Neil Angus, AICP CEP, LEED AP  
Environmental Planner  
**DEVENS ENTERPRISE COMMISSION**  
33 Andrews Parkway  
Devens, Massachusetts 01434

**Re: Accumet Engineering, Inc. – DEC/ Peer Review  
41 Lake George Street  
Level II Unified Permit Application (#D21-064)**

LANDSCAPE ARCHITECT  
PEER REVIEW RESPONSE LETTER

## WB67-TURNING MANEUVERS (1 of 2)

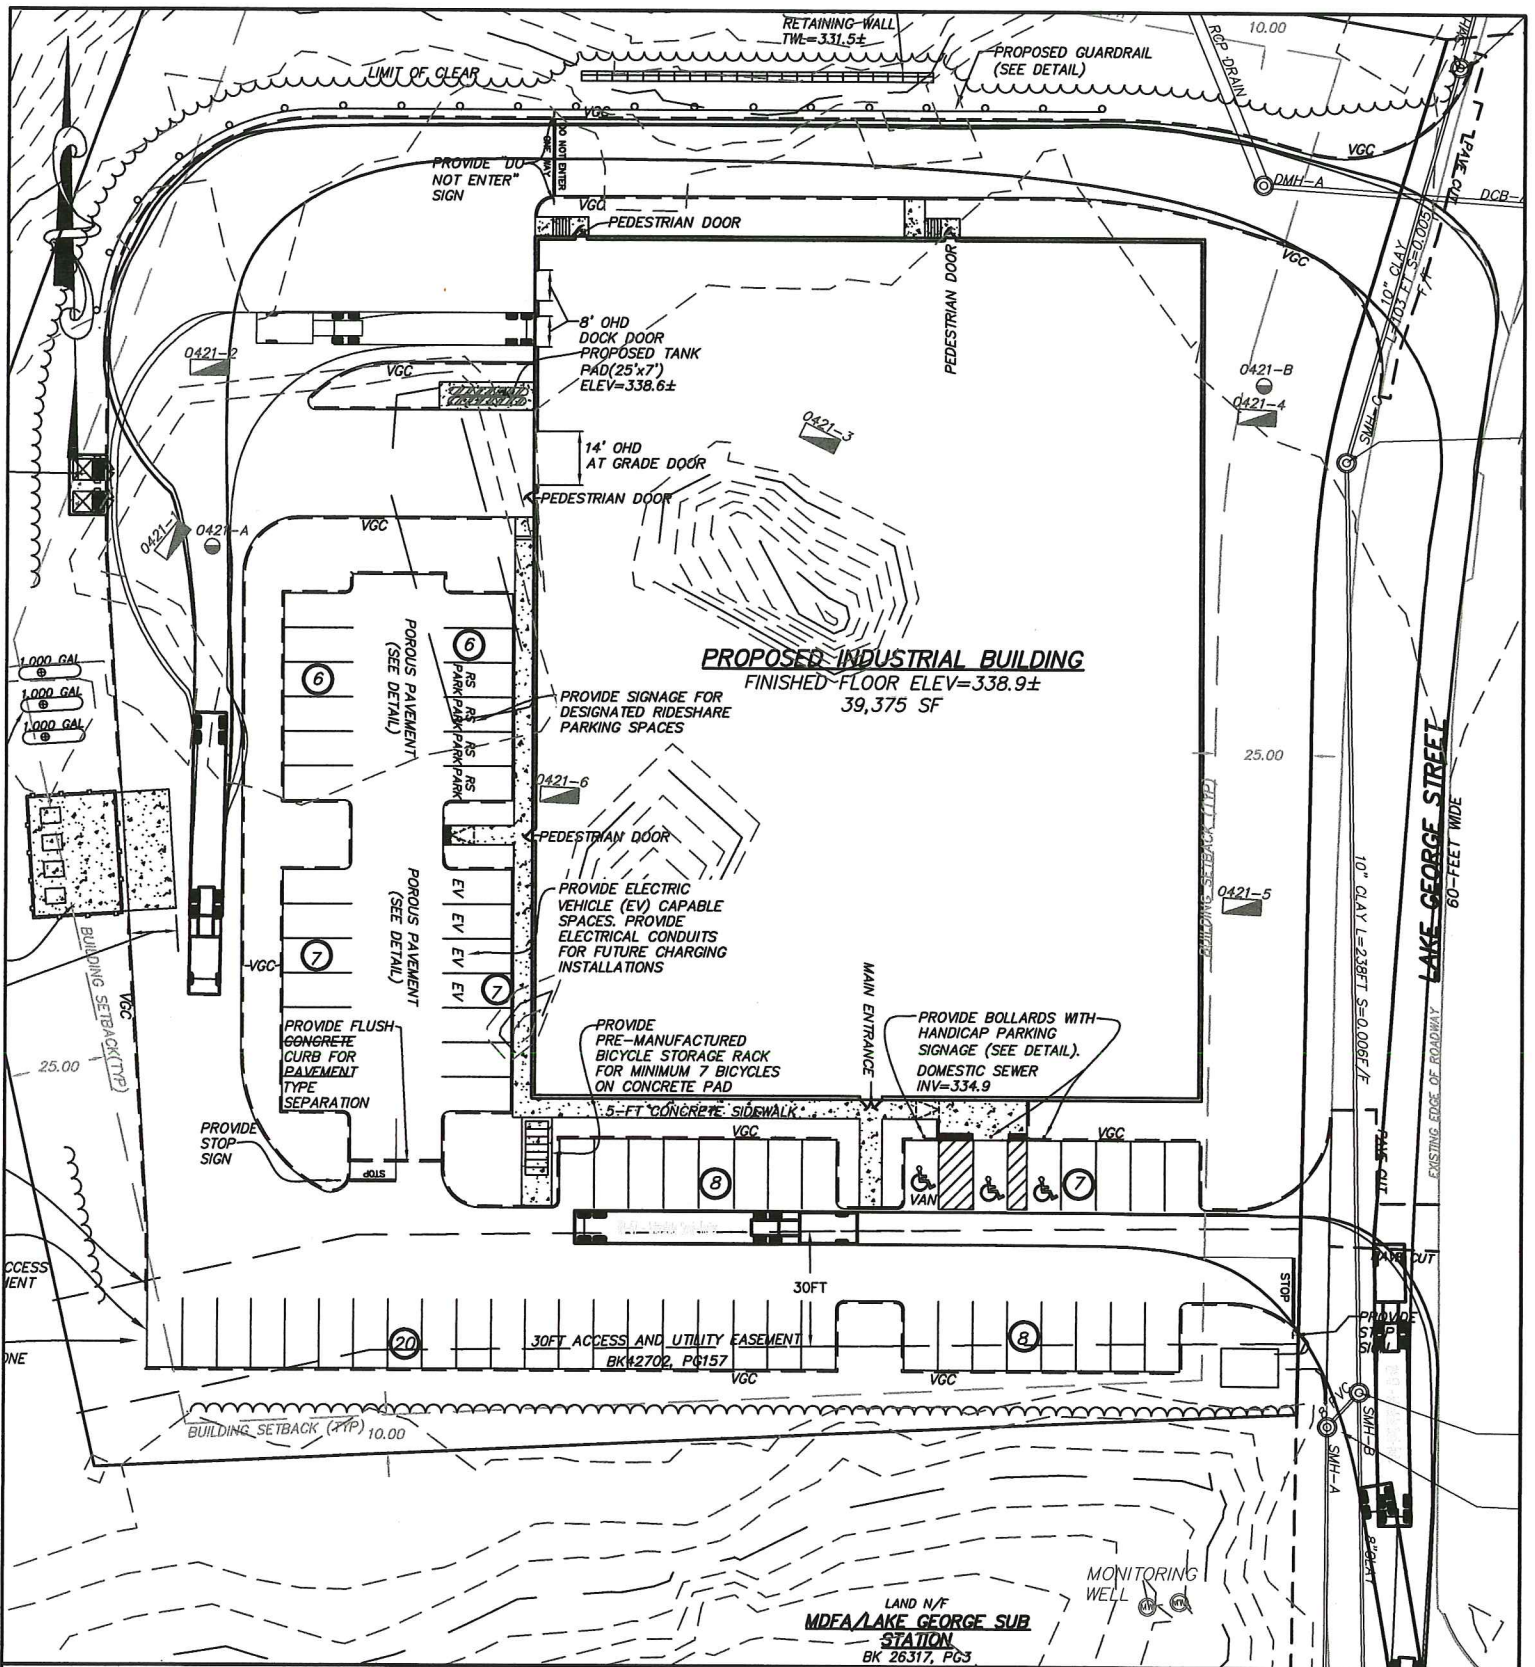
Comment P2: The Applicant indicated that the site was analyzed for truck turning movements to support the roadway widths. We note that the roadways are wider than 24 feet in the back of the building and request that the Applicant provide turning movements to justify increased width in the back.

*Response: This information is provided with sketches attached to this letter. The driveway widths were designed to accommodate WB67 vehicles.*
